**Building Permit Application**  
 Howard County Maryland  
 Department of Inspections, Licenses and Permits  
 3430 Court House Drive  
 Permits: 410-313-2455  
 www.howardcountymd.gov

Permit No.: B15003553

**RE: B15003553**  
**1973 LONG CORNER ROAD**  
**MT. AIRY, MD 21771**

**RE: Variance Approval**  
1973 Long Corner Road  
Mt. Airy, MD 21771

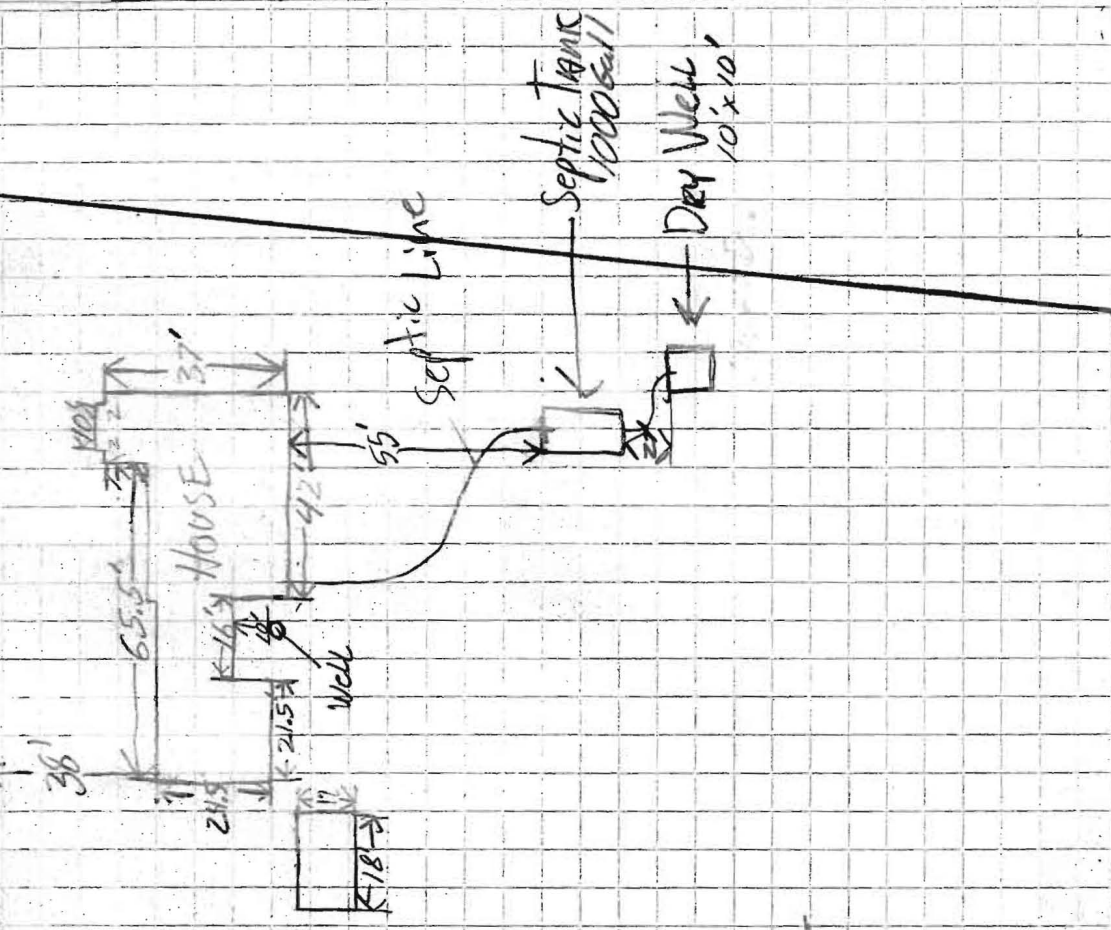
This letter is in response to building permit #B15003553. The application describes construction of a 40 ft X 30 ft pole barn. Upon receipt of the paperwork, the submittal did not include a copy of the floor plans for the pole barn or a scaled site plan detailing the locations of the well and septic system components relative to the house and proposed pole barn.

Building permit approval is being withheld until a scaled site plan, floor plans and percolation certification plan has been received by the Health Department. I've attached a copy of the well and septic setbacks, percolation test and plan requirements for developed lots in addition to the application for percolation testing. Please contact me with any questions.

10/1/15. Site plan approved  
as shown for B15003553  
(30' x 40' garage) - H.P.
